RE: Proposed work within an Electric Transmission Line Easement Strip

Based on ITC's review of your attached plans dated 7/19/10 and revised 9/3/10 for GM Separation Project Number G0900726, Drawing CU-1, ITC would not consider the Project to unreasonably interfere with the exercise of its easement rights, provided that the Project is located so that it does not now or hereafter 1) violate any provision of the National Electric Safety Code ("NESC"), including without limitation, the NESC clearance requirements; 2) block access to ITC's electric transmission structures by ITC's vehicles and equipment for purposes of exercising ITC's easement rights; and 3) preclude the construction of such additional electric transmission lines within the easement strip as ITC may, in its discretion, deem necessary or desirable.

Subject: NOA0102150 Permit to construct underground facilities

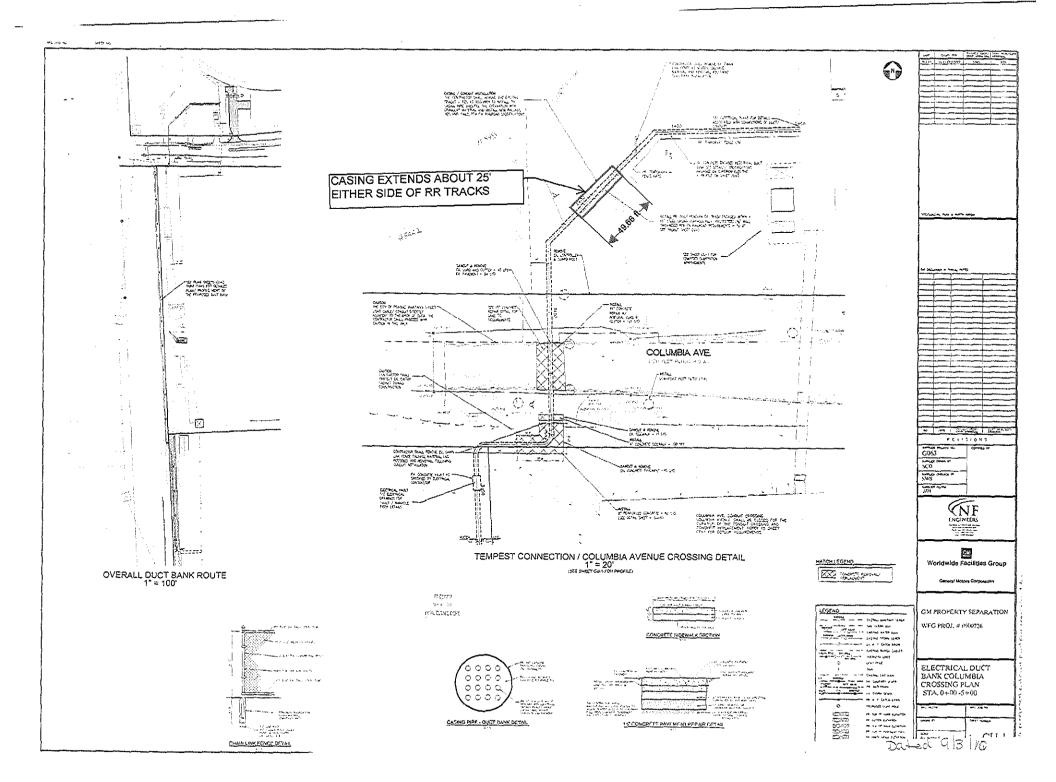
Based on the casing information provided by Steve Sutton, the casing will not affect the subsurface steel of ITC *Transmission* towers 5552 and 5488. Dave

Generally, but just a bit shorter than your bubble. The casing is more or less 25'each way of the center of the tracks at the track – conduit intersection.
